**Devens
Enterprise
Commission**

RE: Emerson Green Multi-Family Apartment Level 2 Unified Permit Amendment Request

2026 Proposed Parking Expansion (23 spaces)

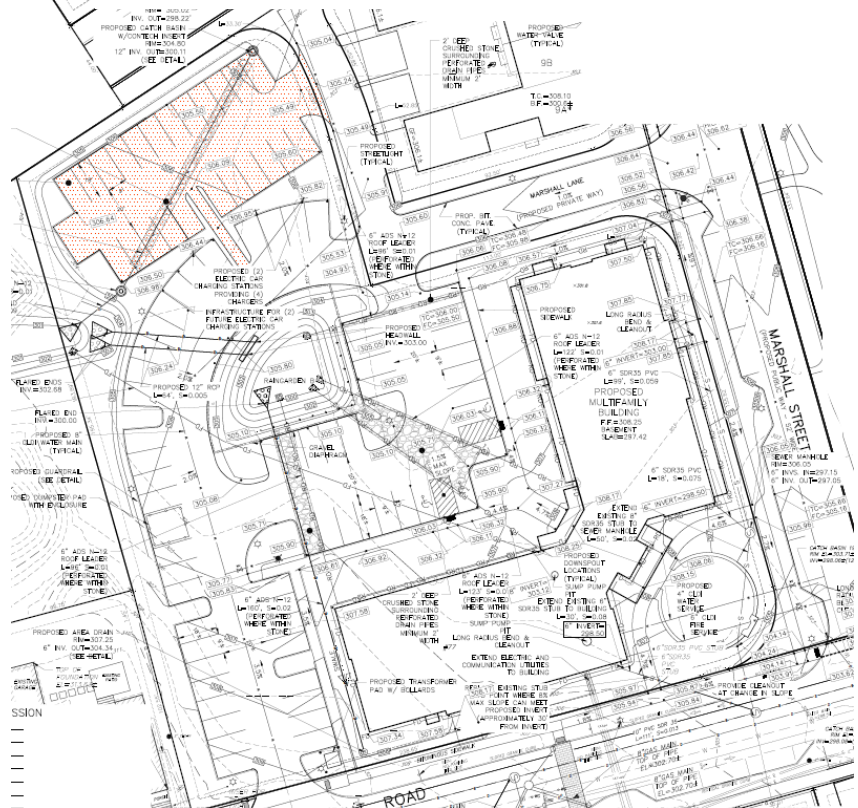
The DEC parking regulations are "maximums". We try to discourage excessive parking through shared parking and transportation demand management strategies. For residential, the DEC allows up to 2 spaces per unit. The approved plans have 60 spaces for 46 units (or 1.30 spaces/unit). The Applicant is proposing an additional 23 spaces for a total of 83 spaces for 46 units (1.8 spaces/unit). The key issue, according to the Applicant, is the number of bedrooms, not the proposed number of units. The approved unit mix is 37% 1 bedroom, 54% two bedrooms and 9% 3 bedrooms, totaling 79 bedrooms. The Applicant has prepared a report detailing their rationale as to why the number of bedrooms should drive the number of parking spaces needed. The DEC allows for parking spaces below the maximum with reasonable justification from the applicant.

ADA Parking: The project currently has 4 ADA parking spaces proposed. With the addition of 23 spaces (83 total), the project will still comply with 974 CMR 3.04(3)(a)1.c. and 521 CMR MAAB (4 required for 76-100 spaces). The existing approved parking lot has 4 ADA spaces.

Snow Storage: Snow storage is not permitted within the rain garden however there is space along the sides of the parking areas where snow for smaller storms can be stored. The Applicant would need to arrange for off-site snow removal in the event of any major snow events.

Stormwater Management: Staff worked with the Applicant to upgrade the approved drainage system for the existing parking lot to provide direct decentralized infiltration below the approved parking lot for the roof runoff as well as the proposed parking spaces, eliminating the need to expand the size of the rain garden. The DEC's peer review consultants noted a few revisions needed for the plans to comply with the DEC regulations and the Applicant has revised the plans to include address these deficiencies. The 'dead' storage below the pipe still needs to be modified to meet the 1-inch required volume for the additional impervious (558 cf). This is included as a condition.

Lighting: The Applicant's original design for the expanded parking area lighting levels that exceeded the DEC requirements. A revised photometric plan was submitted with reduced lighting levels that are more in-line with the DEC's requirements for reduced light pollution (14' poles, dark, earth-tone color, 3000K temp. and fully shielded). The fixtures will match the style of the rest of the development (pedestrian-scale lighting).

- (a) A note shall be included on the lighting plan indicating the requirement for full shielding/recessed lighting source.
 - (b) A note shall be included on the site plan verifying that no outdoor storage of equipment or materials within the parking area is allowed.

- (c) The 'dead' storage below the pipe shall be modified to meet the 1-inch required volume for the additional impervious area.
- 11) Should the additional 23 parking spaces or any portion of them become obsolete the future, the Applicant shall explore options for eliminating pavement or repurposing the space for outdoor recreational use.
